Environmental Review Team Report
Meadowbrook Subdivision
Mansfield, Connecticut

ENVIRONMENTAL REVIEW TEAM REPORT
ON
MEADOWBROOK SUBDIVISION
MANSFIELD, CONNECTICUT

**SURFICIAL
GEOLOGY**

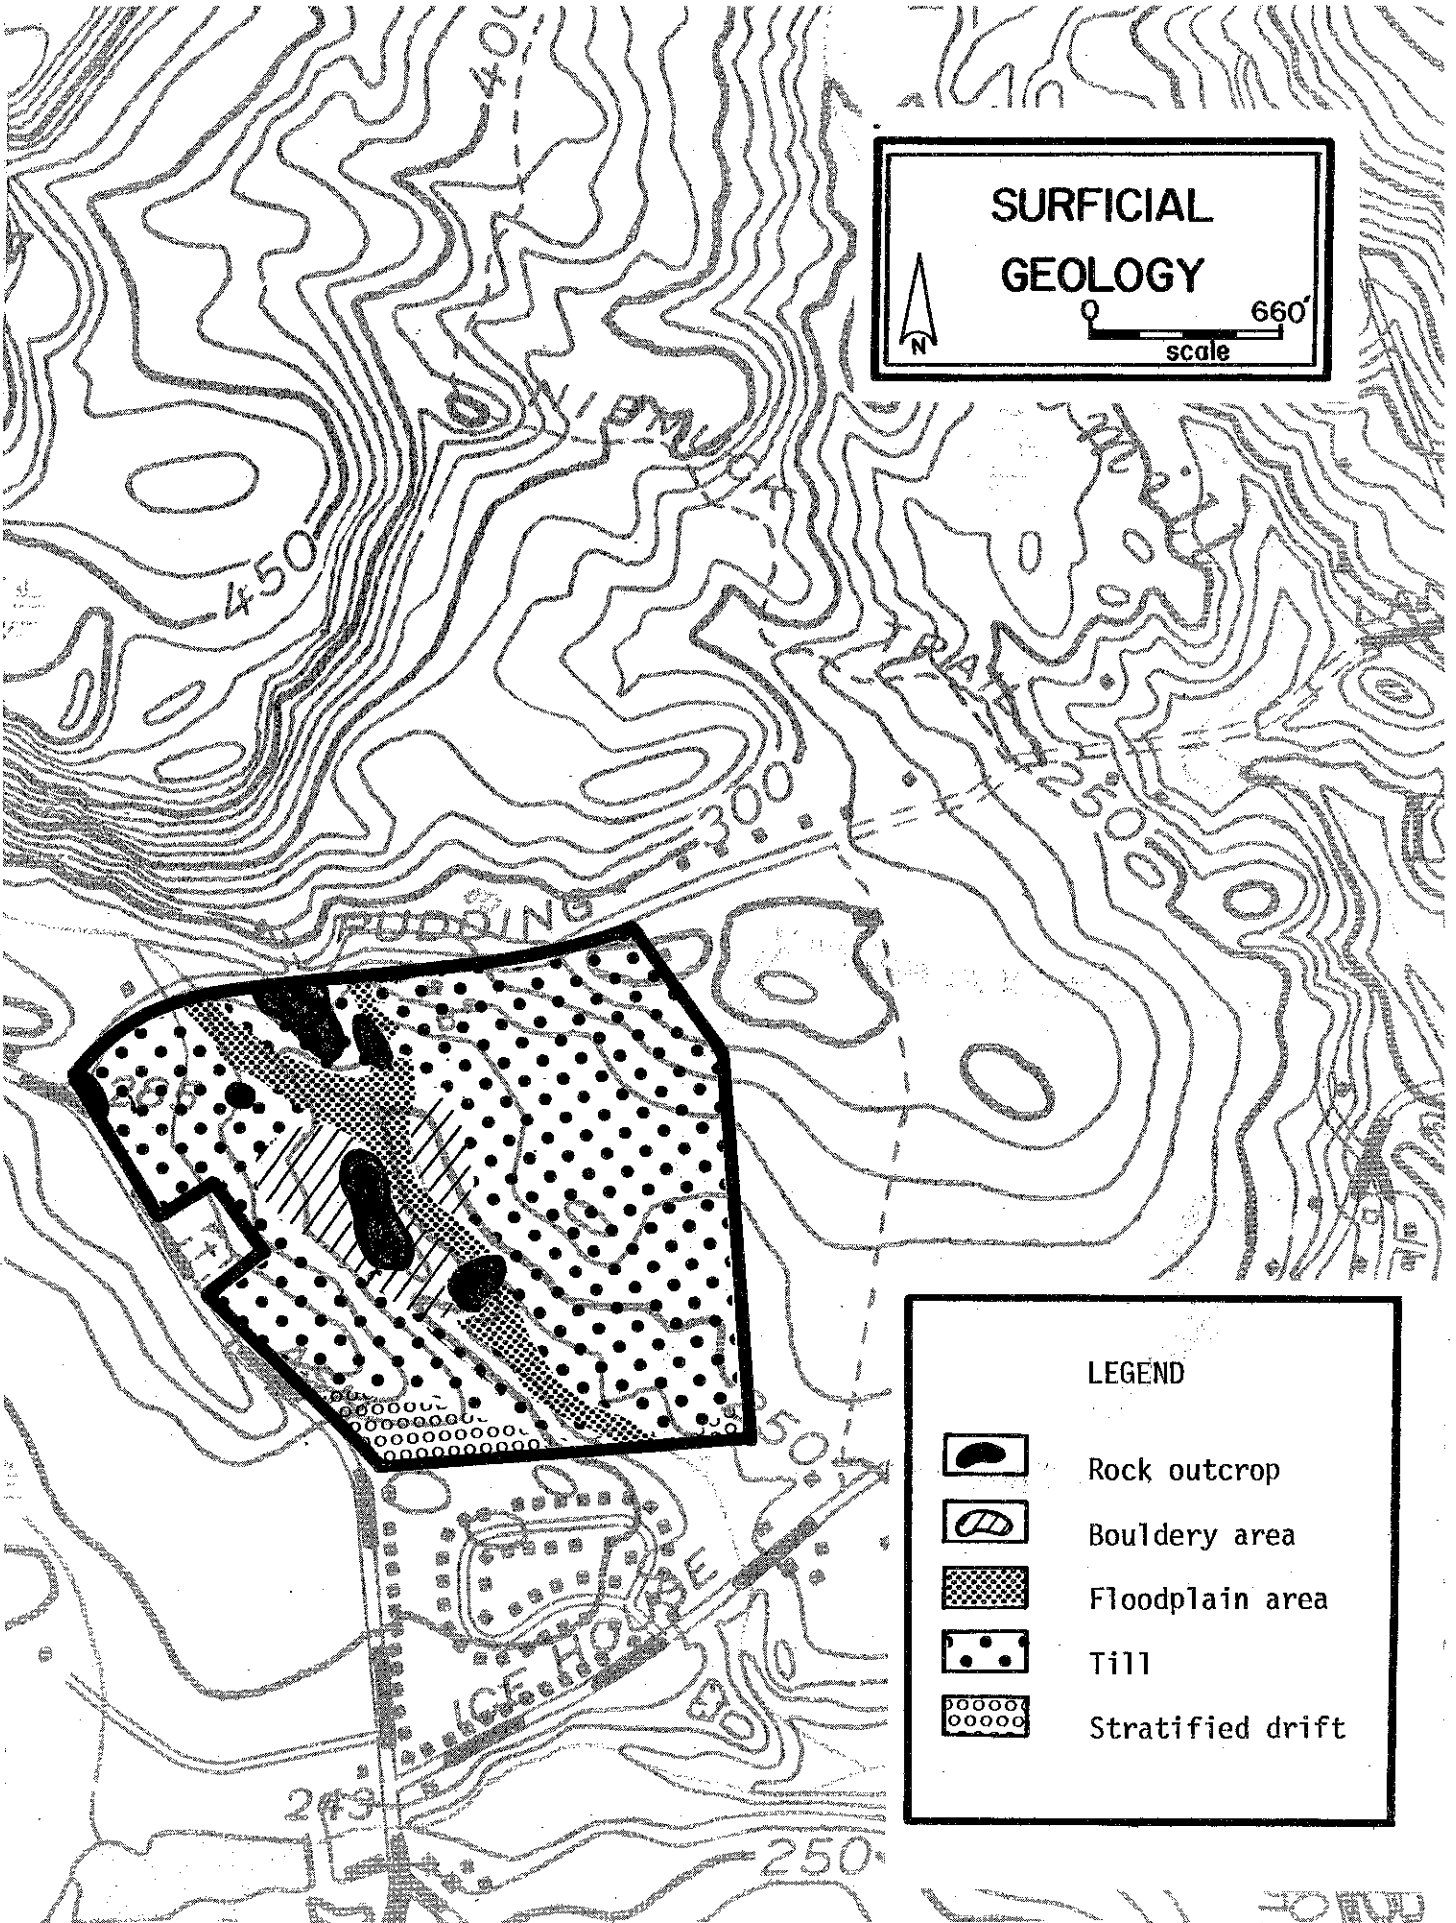
The Meadowbrook Subdivision site contains a thin, unconsolidated blanket of glacial materials over bedrock. The bedrock consists primarily of Willimantic Gneiss, a lineated metamorphic unit rich in quartz and potassium feldspar. The surficial geology of the property is shown on the accompanying map.

This glacial cover comprises two major types of deposits: till and stratified drift. Till covers most of the site; stratified drift is generally restricted to the southern periphery. Till is a mixture of rock particles of various sizes derived from the erosion of bedrock and older unconsolidated deposits by glacial ice. In eastern Connecticut, till is commonly called hardpan because of its shovel-resistant compactness, which also makes it only slightly pervious to water. The characteristic lack of grain-size sorting indicates that the till was applied directly onto the landscape by ice and not later transported by meltwater. Stratified drift, however, was deposited by glacial meltwater and consequently tends to be well-sorted and layered. Typically, stratified drift is composed of sand and gravel, but other grain sizes are found in some areas.

Bedrock is exposed at several places on the property. The location of the outcrops and the irregular topography within the entire subdivision area indicate that much of the interior part of the site, as well as the north and west flanks, is underlain by bedrock at shallow depth. However, test hole information was not available to confirm this hypothesis.

FIG. 2

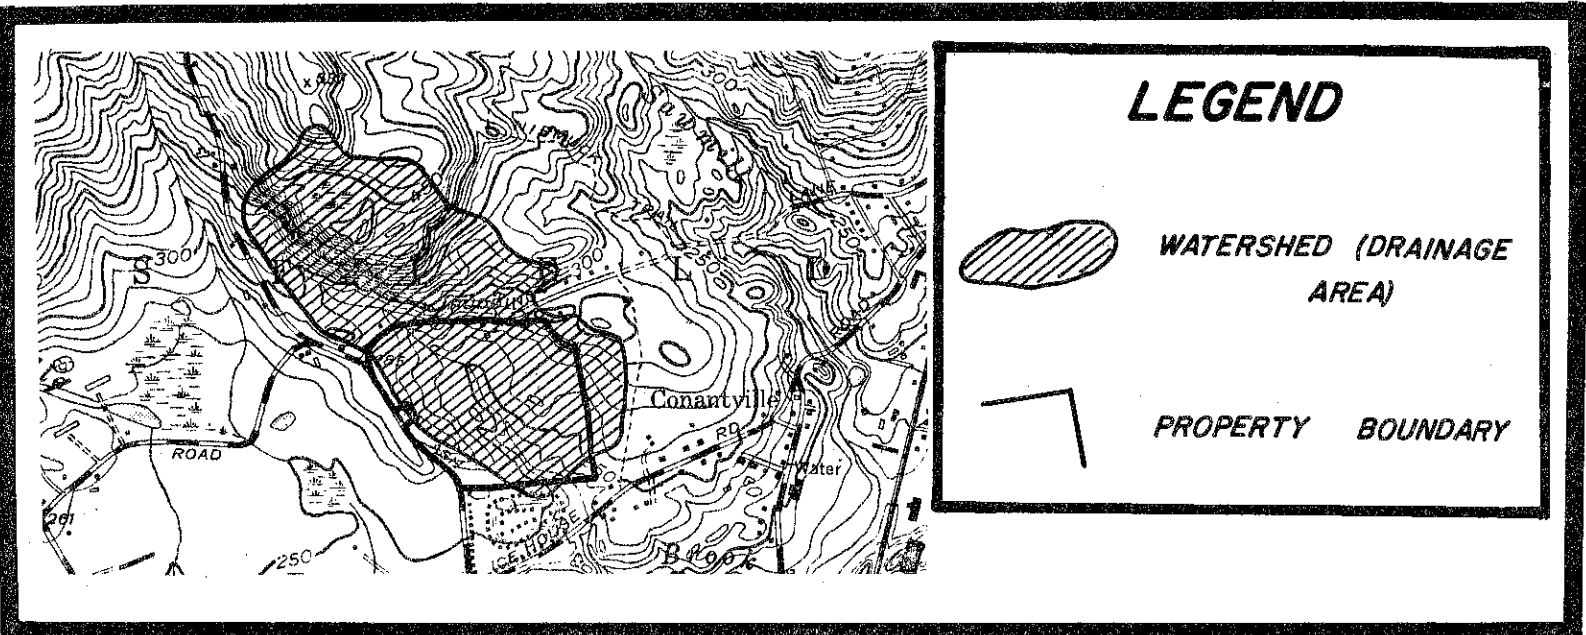
One small brook traverses the property. Water flowing in the brook, from its source to its point of egress from the property, originates in a drainage area of about 170 acres. A rough estimate of changes to peak flow in the brook may be made for a selected storm event by employing a method detailed in the

Soil Conservation Service Technical Release No. 55. The method includes evaluation of soil types in the watershed, present and proposed land use, average topographic slope and other factors. Essentially, the technique involves the determination of present and future runoff curve numbers for the watershed. These numbers relate runoff amounts within the drainage area to total precipitation for a particular storm event. Many assumptions are necessary in order to use the method for this property, as the proposal for development is presently very general. A thorough analysis would require the determination of the total percentage of the watershed to be made impervious to rainfall (as by driveways, roofs, roads, etc.), the present ratio of runoff to rainfall for selected storm events, and other parameters. Despite these limitations, the method can be expected to point out potential problems, if they exist.

Although a detailed presentation of data used in the analysis is not practical here, the assumptions employed were based as closely as possible on the three types of proposals presented at the initial review: (1) development of only 16 one-acre lots bordering on present town roads, (2) development of one-acre lots on the entire property, (3) development of the aforementioned lots plus establishment of 4-unit-per-acre multifamily housing in the interior part of the property.

It was also assumed that no changes would occur in the remainder of the watershed. The runoff curve numbers estimated for each proposal are as follows: no development, CN=65; proposal (1), CN=66; proposal (2), CN=69; proposal (3), CN=67. Table 1 shows the estimated changes in peak flow in the brook derived from the curve numbers. The changes caused by proposal (2) are especially significant, ranging from 25% increased peak flow for the 24 hour-100 year storm event, to 74% increased flow for the 24 hour-2 year storm event. Changes from proposal (1) are relatively small, and changes from proposal (3) are moderate.

The channel of the brook is presently most closely accommodated to the more frequent storm events and their associated runoff. The increases in peak flow estimated for proposals (2) and (3) would force the brook to divert its flow more often to its floodplain. Moreover, the area flooded during the larger, less-frequent storms would probably increase. As a consequence, any houses located near the brook would be likely to suffer with flooded basements, driveways, or yards. Bank erosion would increase downstream from the property, but the impact of such erosion is not certain. The culvert on Meadowbrook Lane just east of Circle Drive should be examined to determine its ability to handle increased flow.

Soils

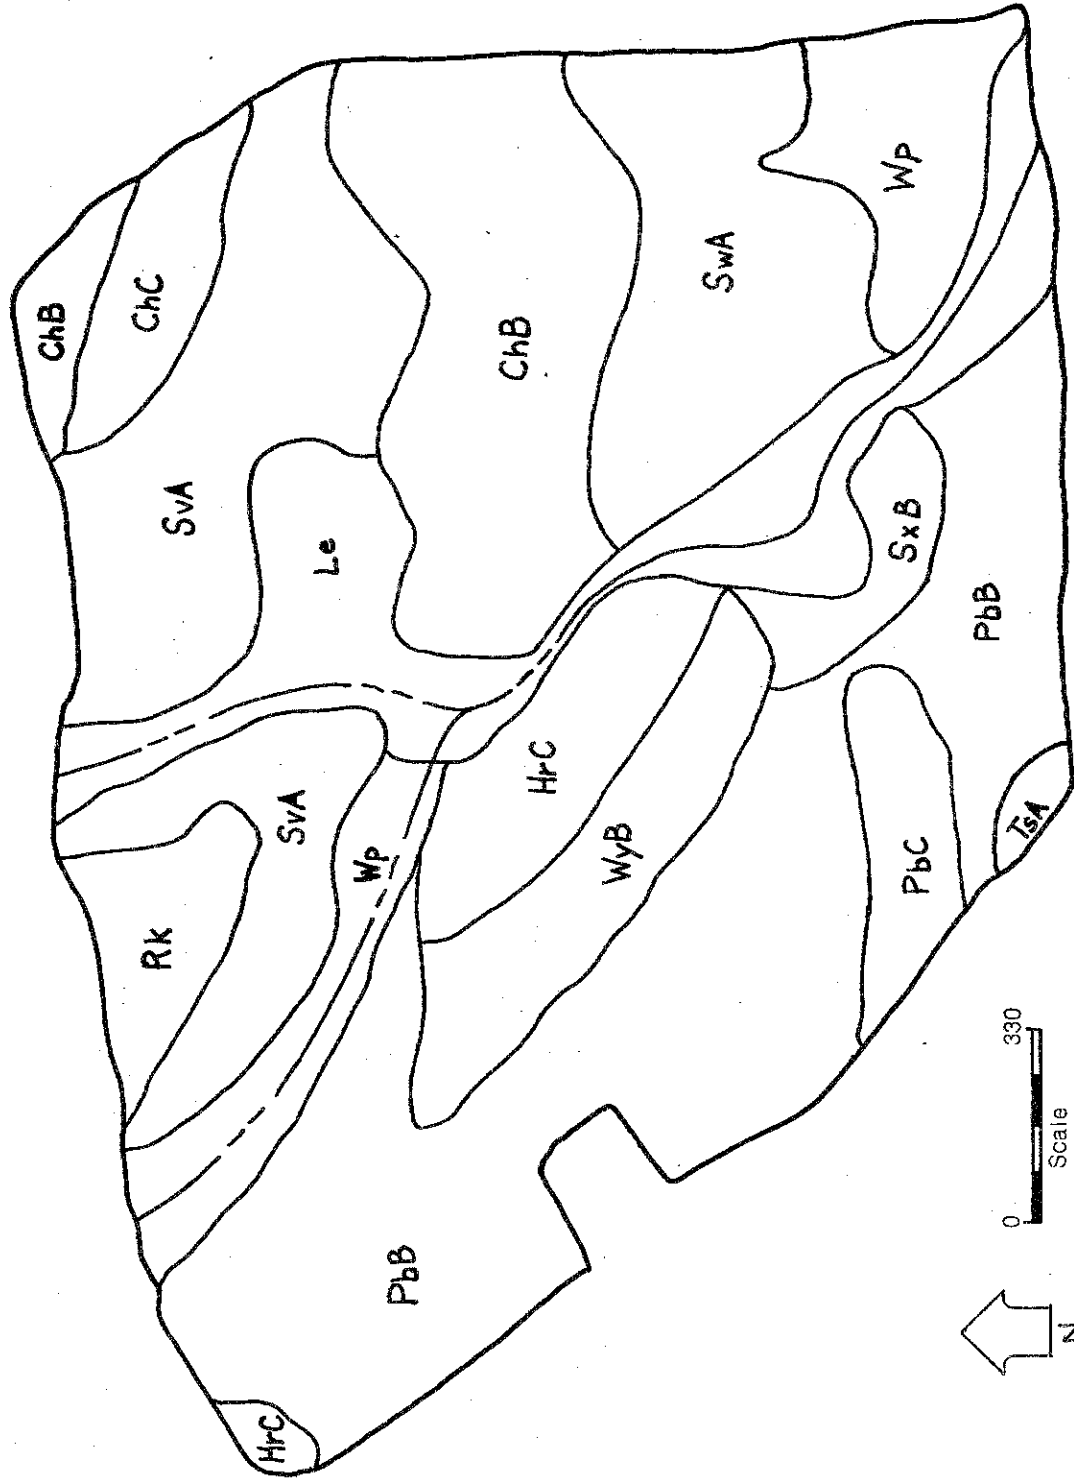
A detailed soils map of this site is included in the Appendix to this report, accompanied by a chart which indicates soil limitations for various urban uses. As the soil map is an enlargement from the original 1,320'/inch scale to 330'/inch, the soil boundary lines should not be viewed as absolute boundaries, but as guidelines to the distribution of soil types of the site. The soil limitation chart indicates the probable limitations for each of the soils for on site sewage disposal, buildings with basements, streets and parking, and landscaping. However, limitations, even though severe, do not preclude the use of the land for development. If economics permit large expenditures for land development and the intended objective is consistent with the objectives of local and regional development, many soils and sites with difficult problems can be used. The soils map, with the publication Soil Survey: Tolland County, Connecticut, can aid in the identification and interpretation of soils and their uses on this site. Know Your Land: Natural Soil Groups For Connecticut can also give insight to the development potentials of the soils and their relationship to the surficial geology of the site.

Soil limitations show that development of the entire parcel may be difficult and costly. Approximately 12 acres of the entire 80 acre site are moderately limited for on-site septic systems, the remaining 68 acres are rated severe. Limitations for buildings with basements are severe for 37 acres of the parcel and slight for 20 acres of the site. Schematic designs for the total 80 acre parcel show road locations in areas of moderate to severe limitations for streets and parking areas.
